Re: Cork City Council Reference No: 25/44442
Large Scale Residential Development (LRD). The demolition of 10 no. existing agricultural buildings / sheds and log cabin residential structure and the construction of a residential development of 140 no. residential apartment units over 2 no. retained and repurposed farmyard buildings (A & B) with single storey extension and 3 no. new blocks of 3-5 storeys in height, with supporting resident amenity facilities, crèche, and all ancillary site development works. The proposed development includes 140 no. apartments to be provided as follows: 70 no. 1-bedroom, 12 no. 2-bedroom (3 person), 57 no. 2-bedroom (4 person) and 1 no. 3-bedroom. Block A and Block B will be retained for resident amenities. The proposal includes a new pedestrian/cycle bridge over the adjoining Passage West Greenway to the east, connecting into the existing down ramp from Mahon providing direct access to the greenway and wider areas, as well as new pedestrian access to Bessborough Estate to the north including upgrades to an existing pedestrian crossing on Bessboro Road. The proposed development provides for outdoor amenity areas including publicly accessible parkland,

Figure 01: Relationship between Block C and Bessborough House

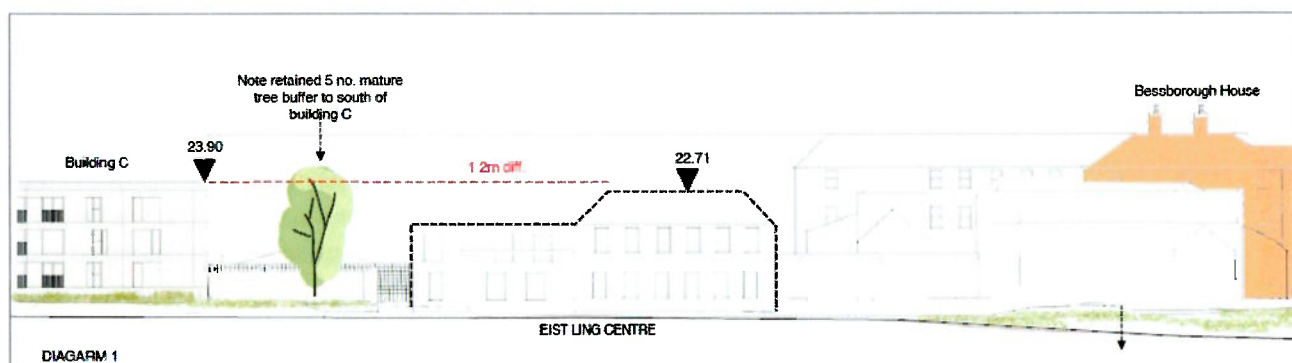
A key conservation criticism of the scheme is the opinion that the presence of Block C would alter the last vestiges of the approach and reveal to the main house. The reading of the main structure as per 1841 Map clearly shows the reveal of the main house after passing through the main avenue to the north and on arrival from the west at the forecourt. The design and siting of building C does not alter the experience as read from this map and a significant tree line is maintained as visual cover to mitigate any visual sensitivity. As illustrated in the Architectural Design Statement, the approach today to the main house is an experience of open landscape to the West and a heavy treelined approach to the east side of the avenue. It is objectively considered that the proposed design approach does not alter the approach landscape-setting of the main house. This clear rationale was presented in the submitted application and is not commented upon by the Council.

Ultimately, the Conservation Officer retains a general view that the location of Block C undermines and impacts the setting of Bessborough House. Based on an objective review of proposed design in the context of the protected structure, the Applicant respectfully submits that this is not a rational conclusion. As per the submitted Historic Landscape Assessment, the original design of Bessborough House was developed to present itself / experience it from the South where the building presents in a dominant elevated manner overlooking the lower parkland area directly to the South. This prominence and scale is protected with the current proposals located significantly to the rear/north (as allowed under the land use zoning) and not impacting this experience. The architectural diagrams submitted display this significant distance from the house itself. It also confirms that mature trees will be retained between the house and Block C. On the ground, it is very evident that significant later building extensions around Bessborough House have altered and compete with the hierarchy of the main house. The proposed design complements the courtyard scale beyond this and will not result in any significant or negative impact on Bessborough House.

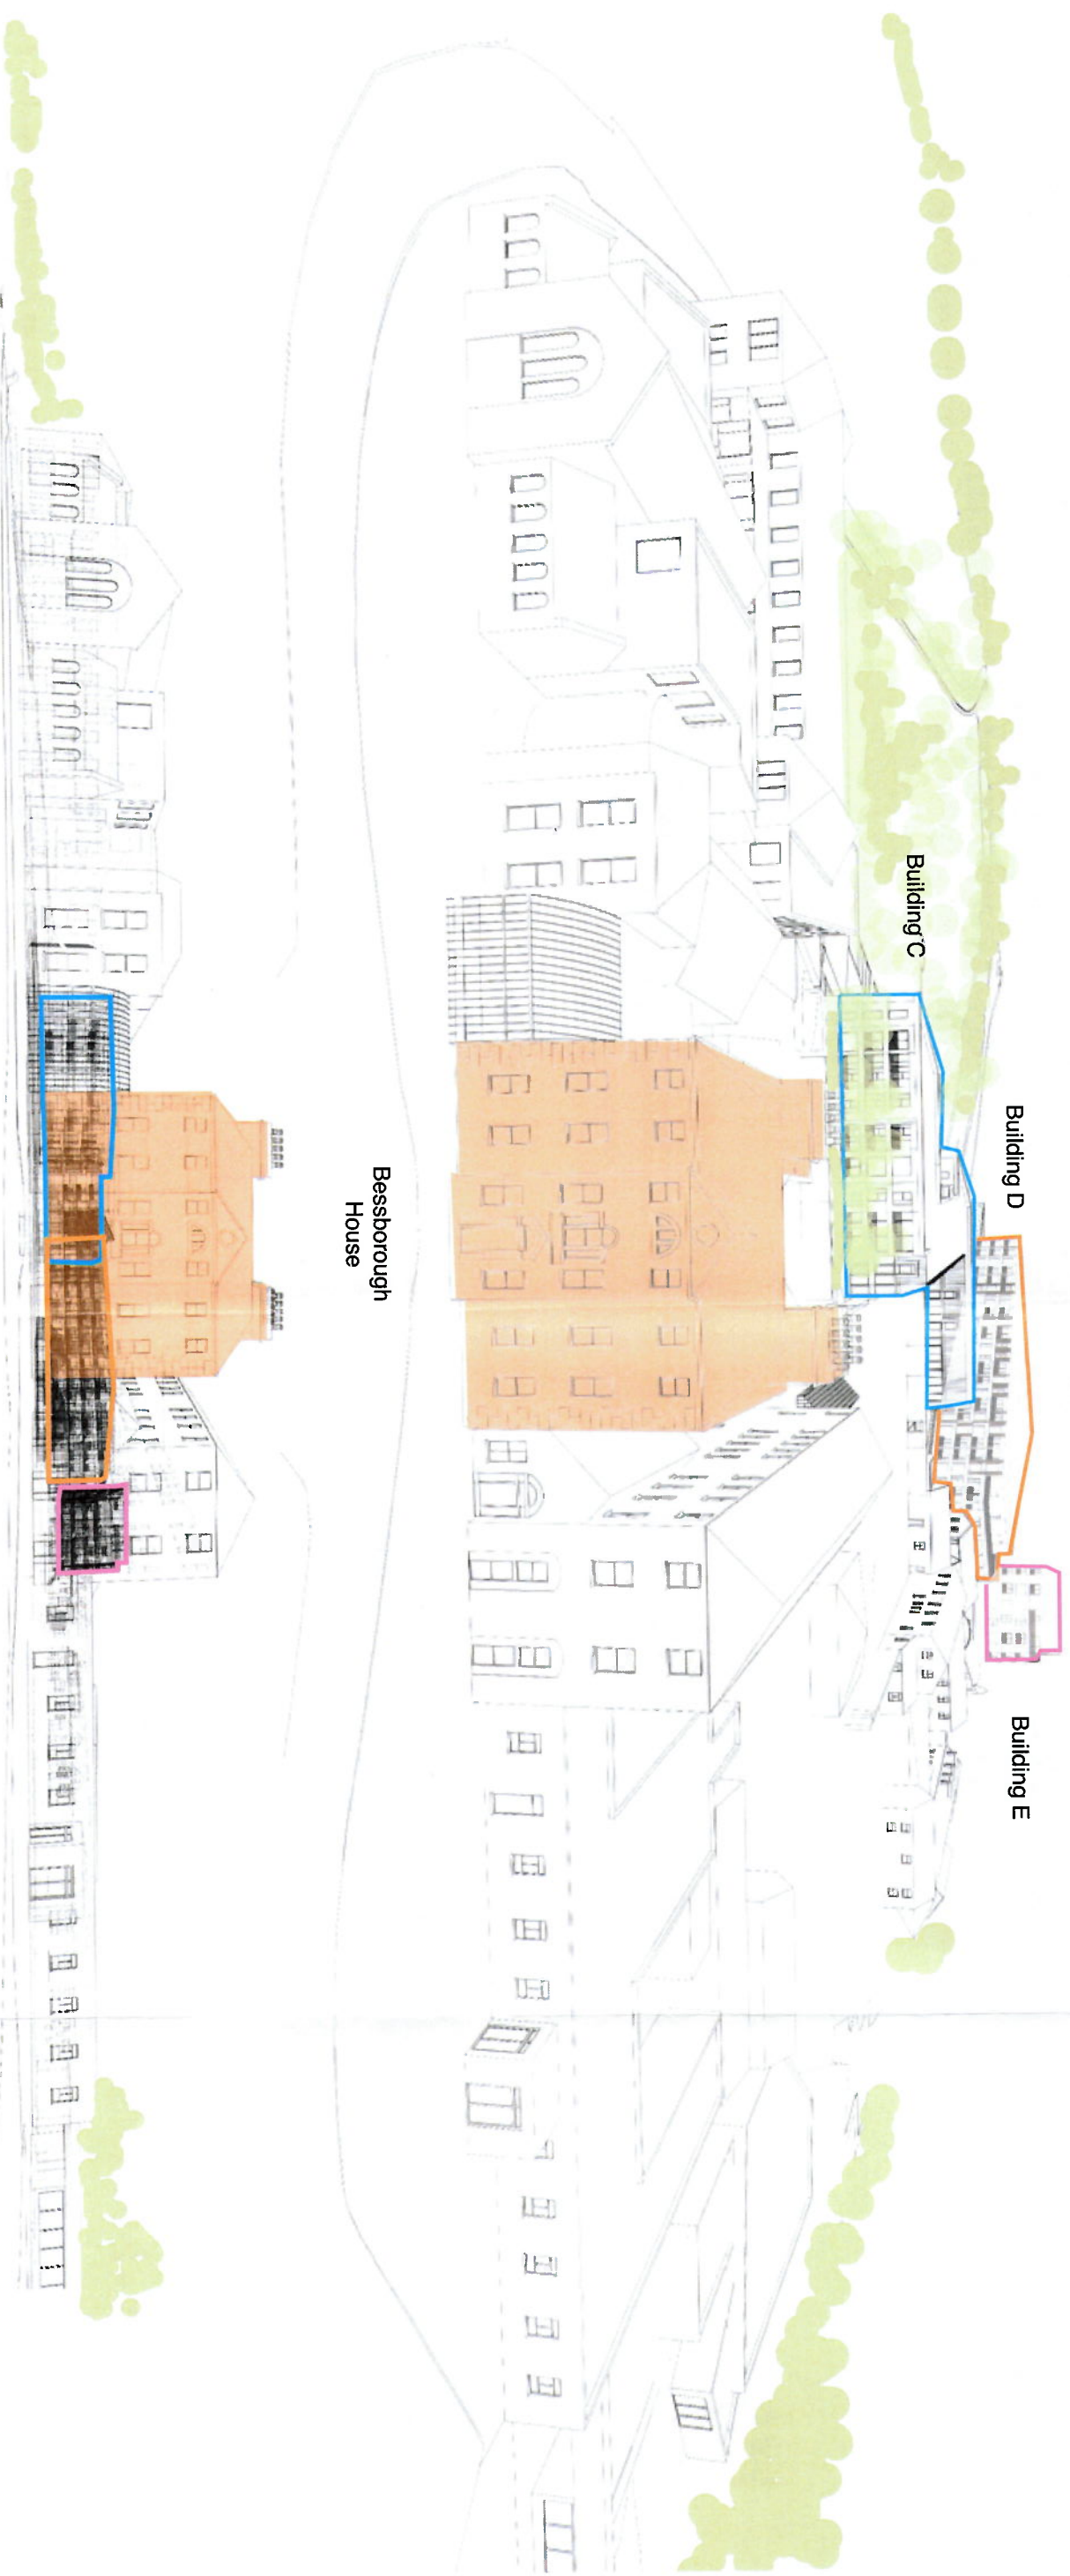
The avenue approach was originally intended as a processional open approach with expansive lands to the east and west. Later planting to the east landbank formed the heritage park and diminished this original intent. The proposed development maintains 6 acres of this new parkland and critically offers this for public enjoyment from its current private secure holding status. We contend the development ,in particular building C, activates and offers supervision to the parkland area with a modest impact to the sylvian setting when viewed in totality. 335 trees are retained on site, 116 new trees are proposed within the development , 49 trees are impacted in total, 33 of which are non-native. Of the 16 Native trees impacted 3 are of category A .

The avenue approach retains a strong, mature eastern buffer, which will effectively screen the proposed development to the west. As a result, the character of the approach to Bessborough House is preserved, with the house continuing to be revealed as a focal point at the culmination of the avenue and from the south.

BUILDING E – 2-DIMENSIONAL ASSESSMENT VERSUS SPATIAL EXPERIENCE

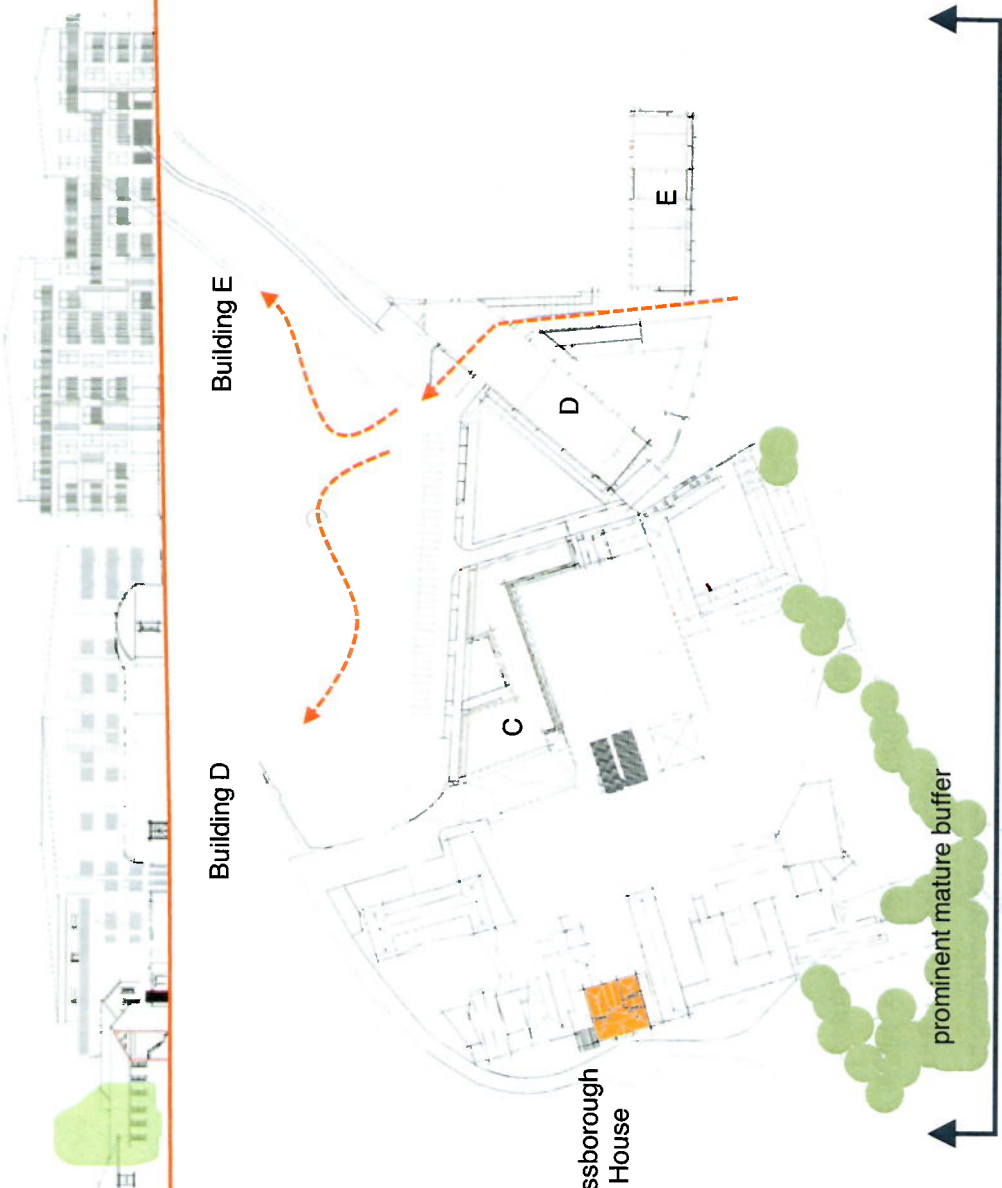
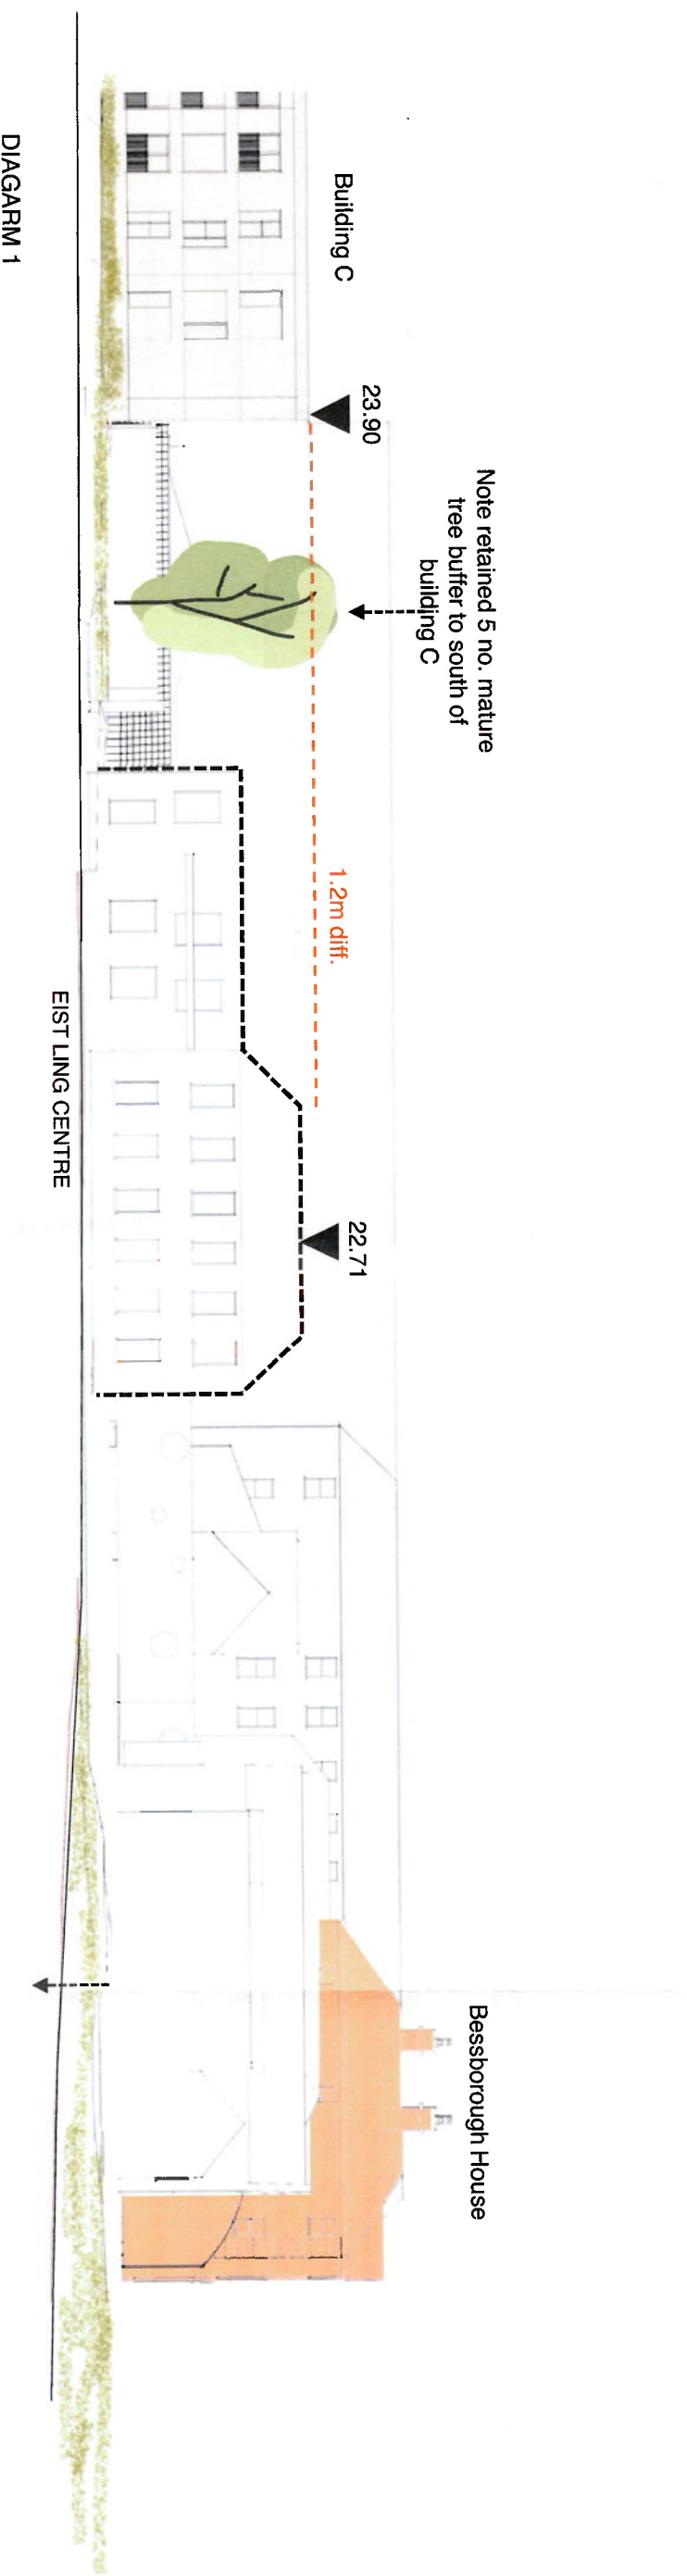
Again, the assessment of the assembly of proposed buildings as viewed from the east presents a significant separation in both distance and reading. The mature boundaries to the east offer a very distinct separation to the legibility and hierarchy on site. Building E's height is justified in its distance from the main house, and the gateway nature of the public access presented at this entry point to the park beyond. The form and materiality of building E offer distinction from the existing lower scale farmyard masonry buildings to the south.
